REVISED BRIDGE POST DETAIL

DRAWTER JAC
DATE 3/3/11
CHECKED MTD
JOB#
POST DETAILS
RIPTON
CCS CONSTRUCTORS, LLC
PROJECT NO. FN010-1(42)
DWG. NO. 1 OF 1

20 REQ'D. RAIL POST MARK "P1"

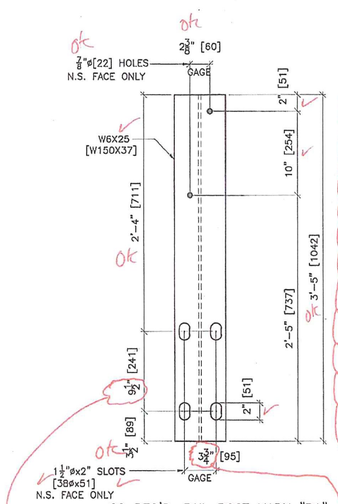
Please find a revised shop drawing attached for the Ripton bridge rail posts. We have verified that the vertical spacing between anchors in the field is closer to 9 ½" than it is to 10". Also, the gage of anchors in the field varies somewhat and tends to be slightly larger than 3 5/8". I had the fabricator include both metric (SI) and US Customary units so that people can easily verify dimensions in the field with readily available tape measures, and so that structures can easily compare dimensions to the standard.

APPROVED AS NOTED PER ANDY'S EMAIL TO MARK MACKINTOSH ON MARCH 16, 2011 @ 3:28 PM
COPY IN CLOUD ABOLE.
Shemund G Frost
3-18-2011
